Economic Commission for Europe**Inland Transport Committee****World Forum for Harmonization of Vehicle Regulations****189th session**

1958 Agreement:**Consideration of draft amendments to existing UN Regulations submitted by GRE****Proposal for Supplement 5 to the 07 series of amendments to
UN Regulation No. 48 (Installation of lighting and light-
signalling devices)****Submitted by the Working Party on Lighting and Light-Signalling***

Model A
(See paragraph 4.4. of this Regulation)

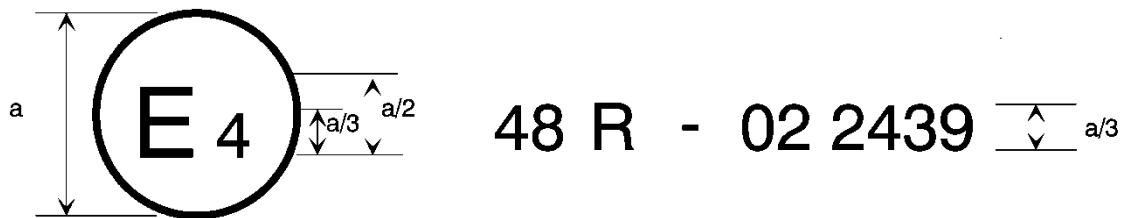
Annex 2, amend to read:

The above approval mark affixed to a vehicle shows that the vehicle type concerned has, with regard to the installation of lighting and light-signalling devices, been approved in the Netherlands (E4) pursuant to UN Regulation No. 48 as amended by the 07 series of amendments. The approval number indicates that the approval was granted in accordance with the requirements of UN Regulation No. 48 as amended by the 07 series of amendments.
